FED. ROAD DIST. NO.	STATE	FED. AID PROJ. NO.	FISCAL YEAR	SHEET NO.	TOTAL SHEETS
HAWAII	HAW.	I-H3-I(61)	1990	281	424

HALAWA APPROACH

HAIKU APPROACH

DATE	REVISION
8/6/92	REVISED DOMESTIC WATER GPM AND SANITARY GPM & TANK SIZE PER DCN61-031
4/26/90	DELETED NOTE: 25 GPM FROM CONTROL BUILDING
STATE OF HAWAII DEPARTMENT OF TRANSPORTATION HIGHWAYS DIVISION WATER BALANCE DIAGRAM STANDARDS INTERSTATE ROUTE H-3 F.A.I. PROJ. NO. I-H3-I(61)	
SCALE: NONE	DATE: JAN 1990
SHEET NO. M2	OF 8 SHEETS

PUMP ROOM SECTIONS

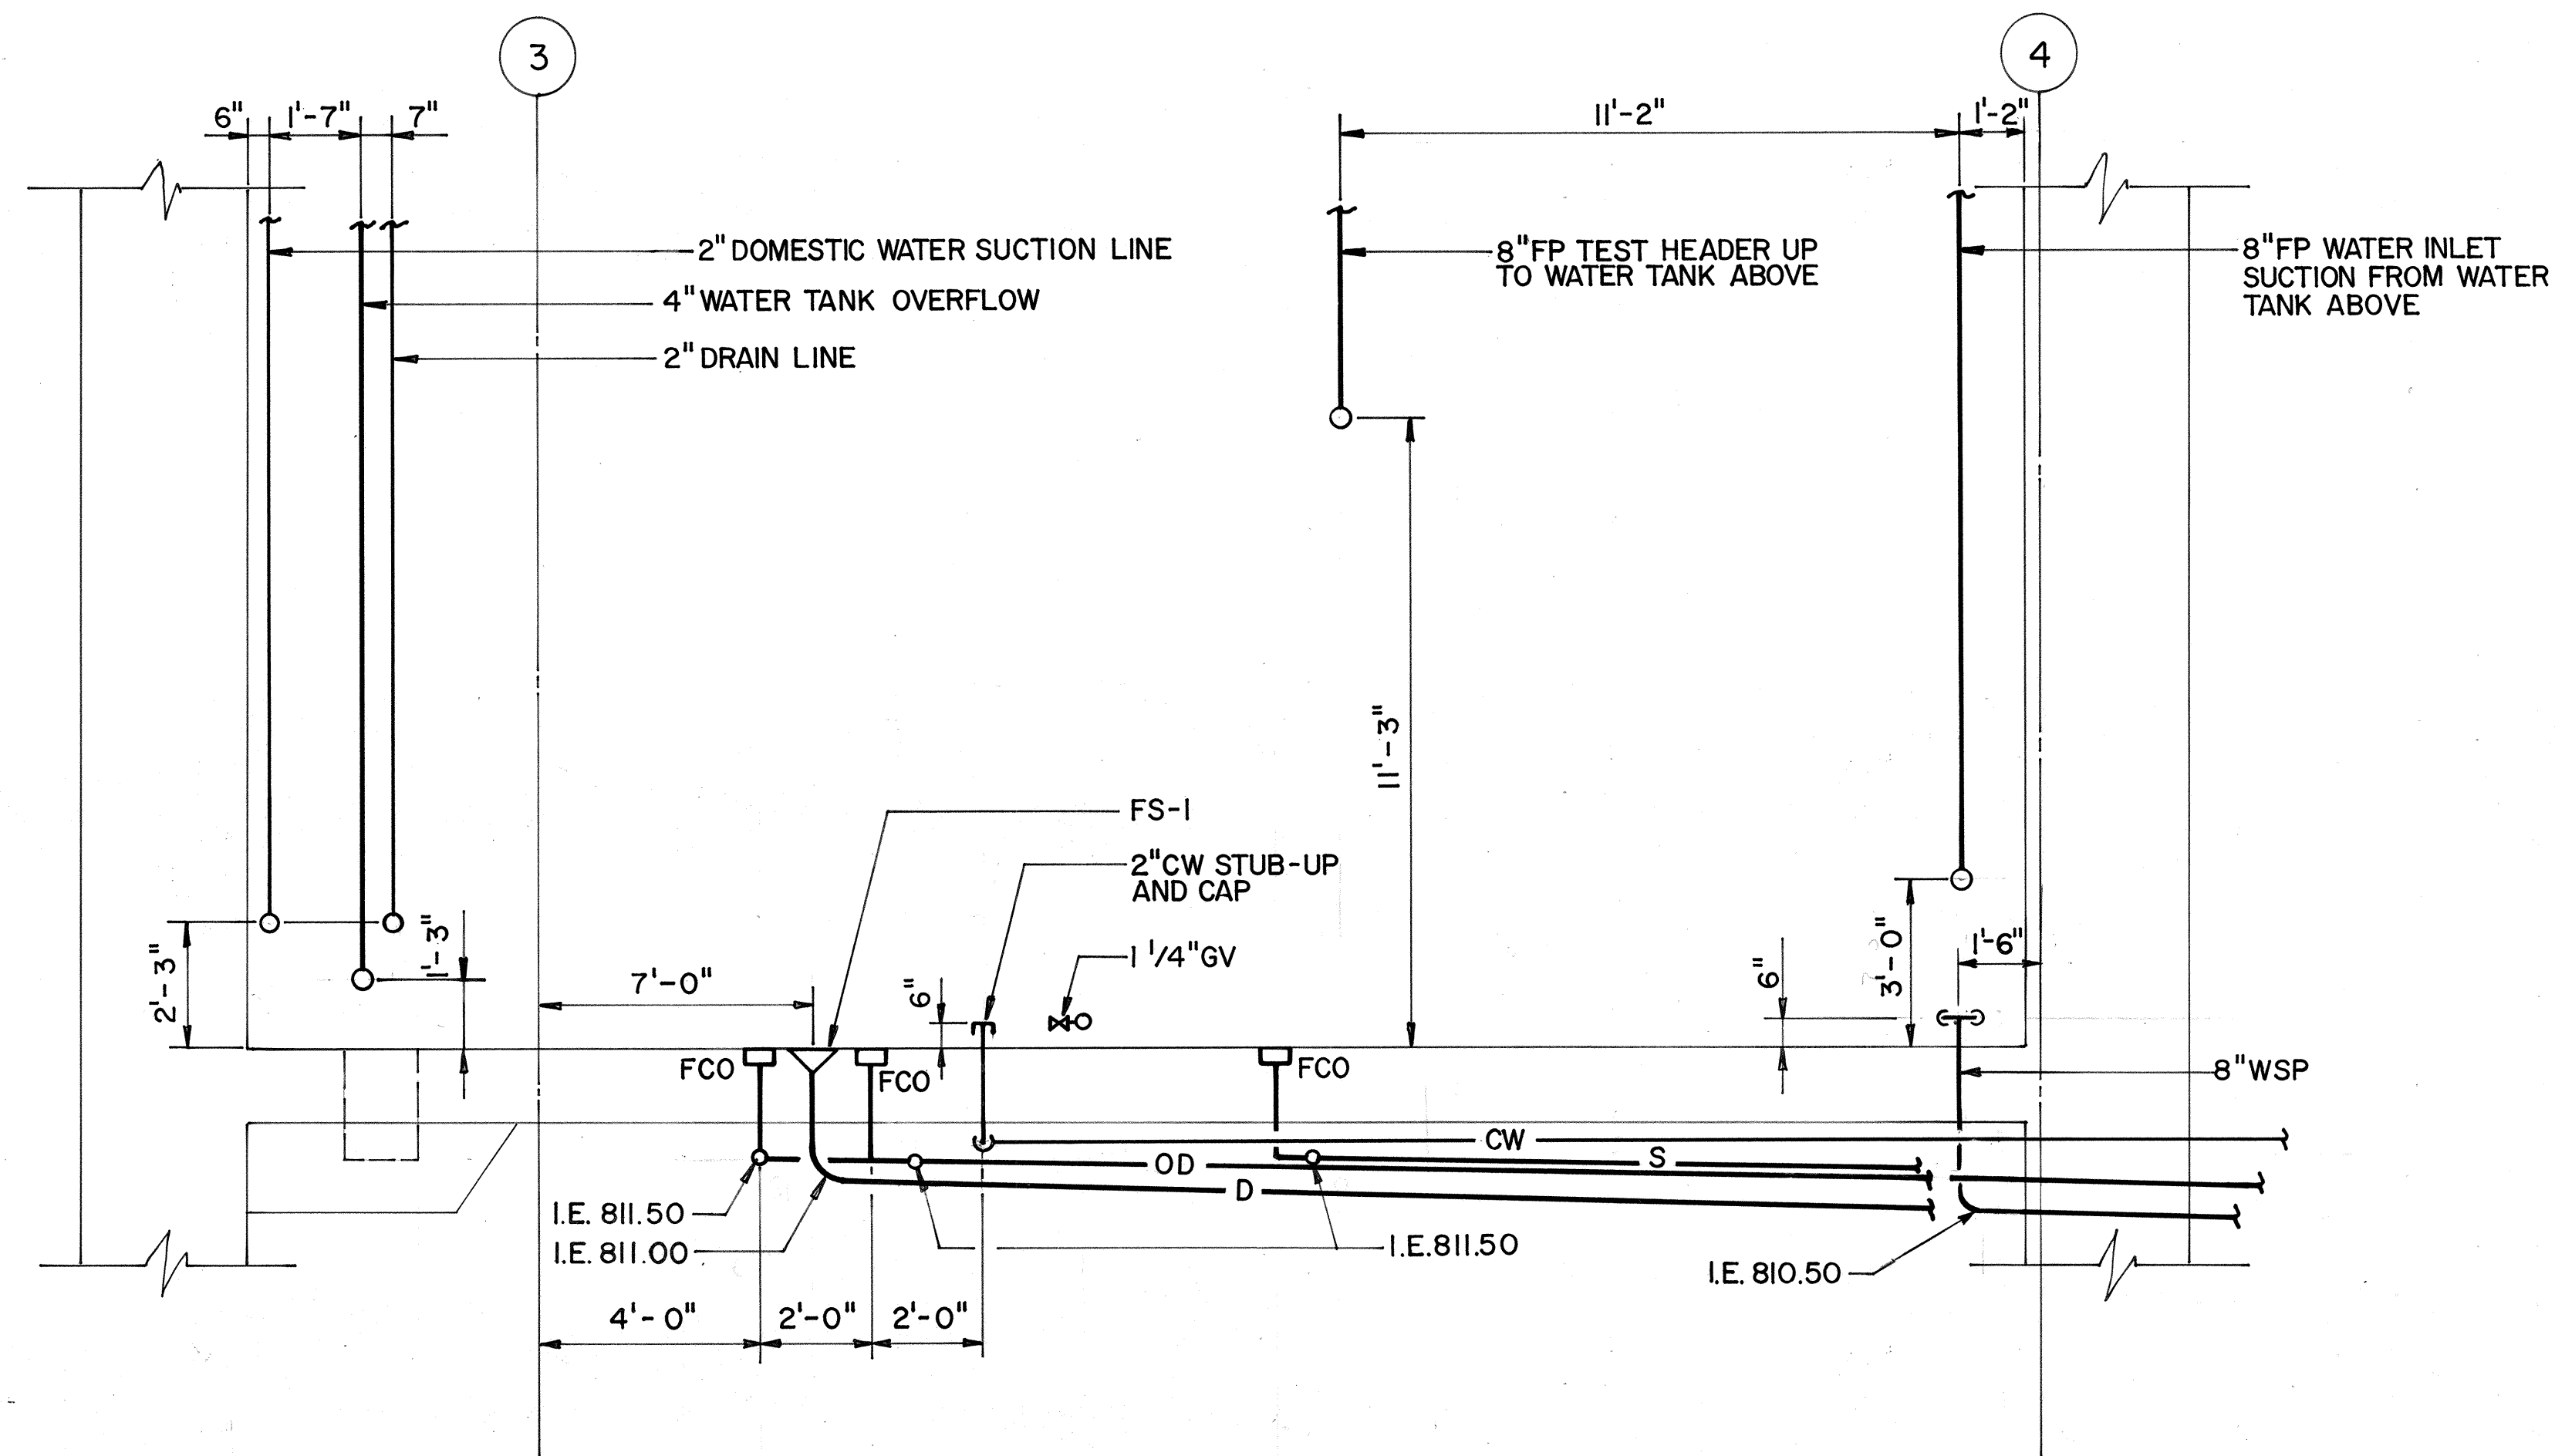
4/26/90	RELOCATED 8" WSP STUB-UP
DATE	REVISION

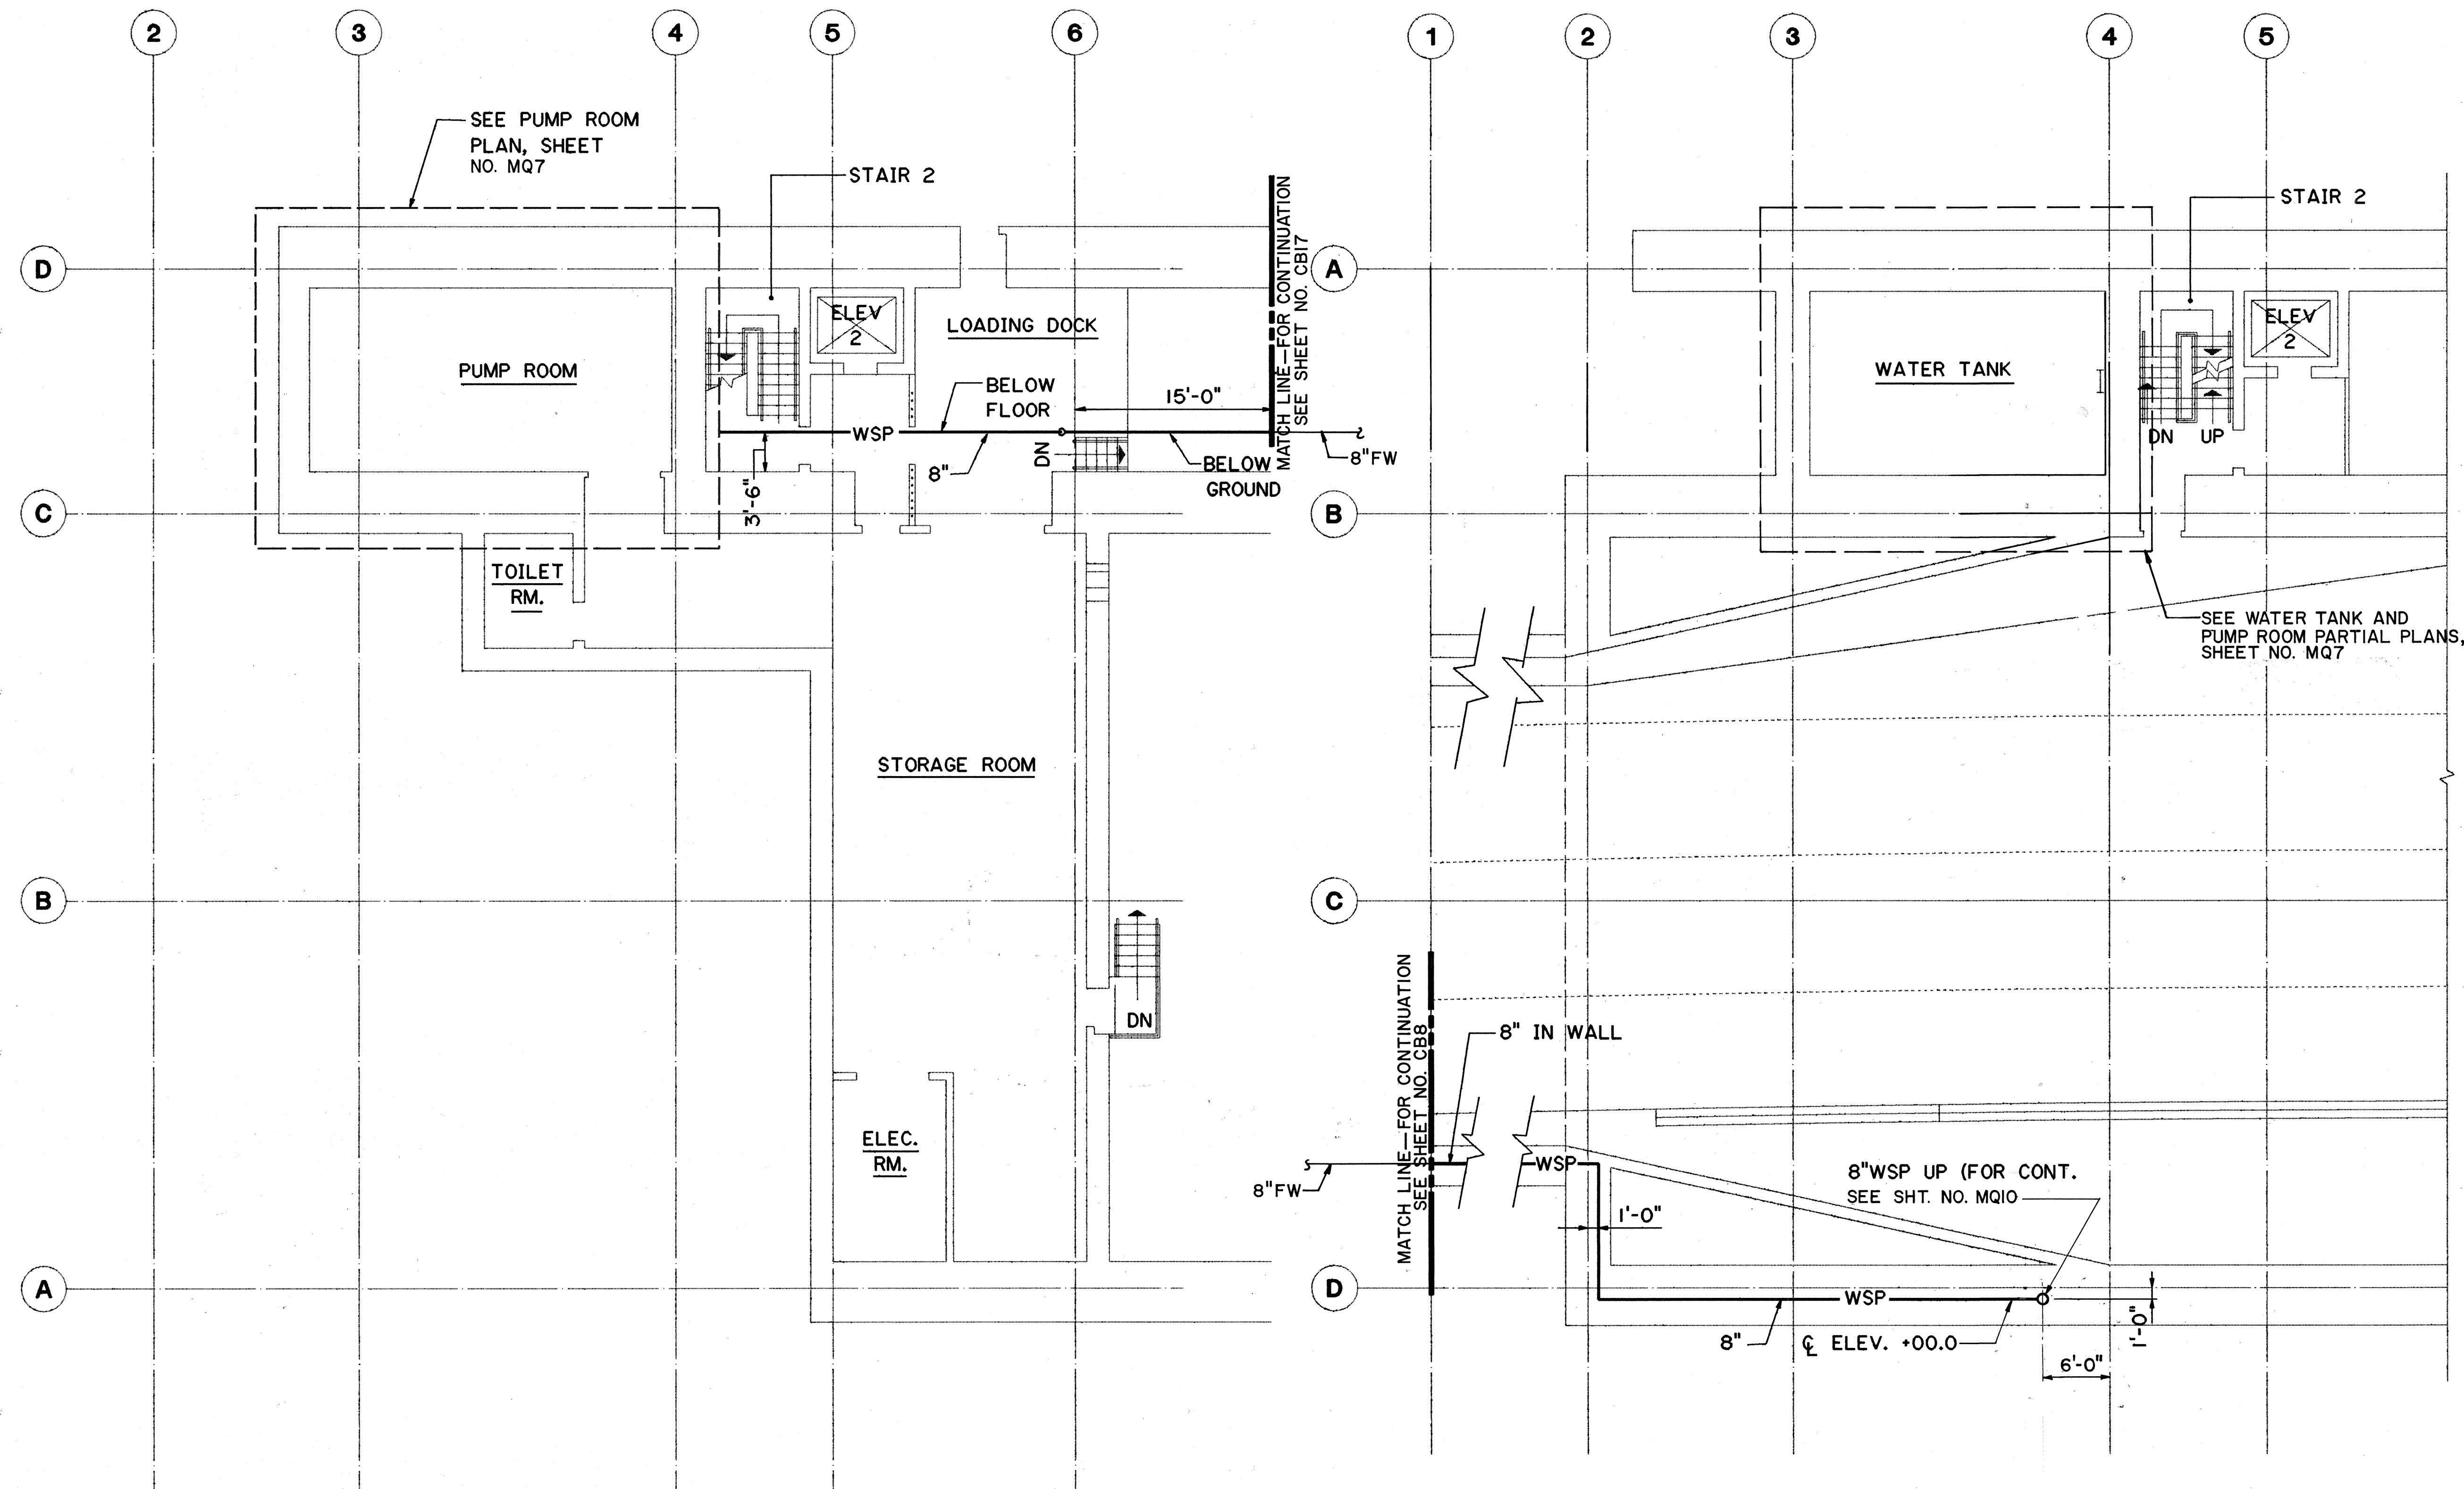
4/6/91	REVISED 8" WSP PIPE DIMENSION PER DCN No. 61-009
DATE	REVISION
STATE OF HAWAII DEPARTMENT OF TRANSPORTATION HIGHWAYS DIVISION FIRE PROTECTION-LEVEL A & LEVEL I PARTIAL PLANS HAIKU PORTAL BUILDING-OB INTERSTATE ROUTE H-3 F.A.I. PROJ. NO. I-H3-1(61) SCALE: 1/8"=1'-0" DATE: JAN 1990 SHEET NO. MQ9 OF 11 SHEETS
